IN THE DRAWINGS

REMARKS/ARGUMENTS

Claims 1-7, 9, 11-19, and 22-25 are pending. The specification and Fig. 2 are amended to more specifically identify features described in original Fig. 2. Claim 1 is amended. Claims 8, 10, 20, and 21 were canceled previously. Support for the amendment to Claim 1 is self-evident. No new matter is added.

Fig. 2

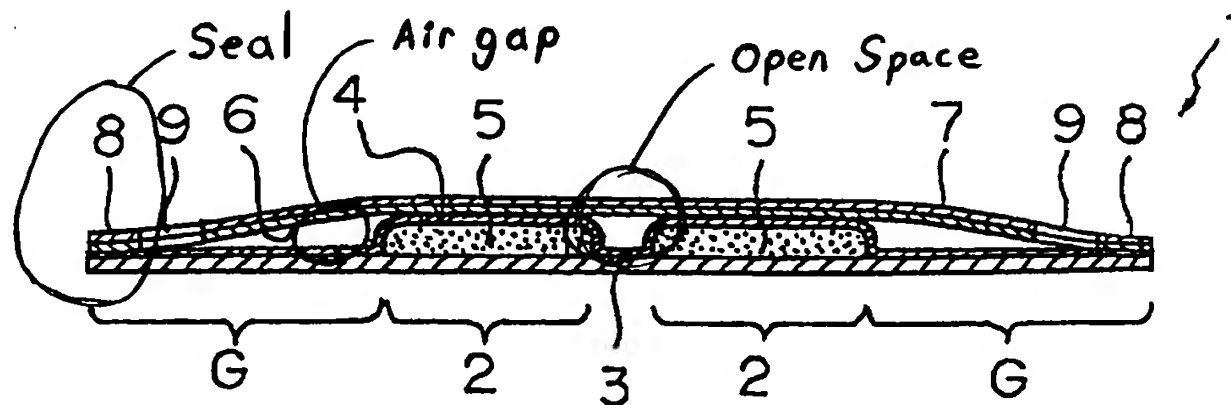
The attached sheet of drawings includes changes to Fig. 2. This sheet, which includes Figs. 1 and 2, replaces the original sheet including Figs. 1 and 2. Fig. 2 now includes one additional reference character.

An annotated version of Fig. 2 is provided below in which a non-limiting example of the seal (8) is identified by name, and the portion between the seal and the heating part, which includes an air gap (A) is marked with the label "air gap."

The specification is amended to discuss reference character (A), added in a replacement drawing sheet submitted herewith, identifying the air gap.

Claim 2 recites "the plurality of heating parts are separated from each other by at least one open space." In the example depicted in annotated Fig. 2 provided above, the open space (W1) separating the heating parts (5) is labeled. The specification is amended to use the term "open space" in describing the area identified by reference character (W1). Accordingly, Applicants respectfully submit that the features added to Claims 1 and 2 in the previous amendment are fully supported by the original disclosure, including original Fig. 2.¹

As the specification is amended to include a reference character referring to the air gap and explicit language regarding the open space, and Fig. 2 is amended to include the above-noted reference character, Applicants respectfully submit that the rejection of Claims 1-7, 9, 11-19, and 22-25 as failing to comply with the written description requirement is overcome.
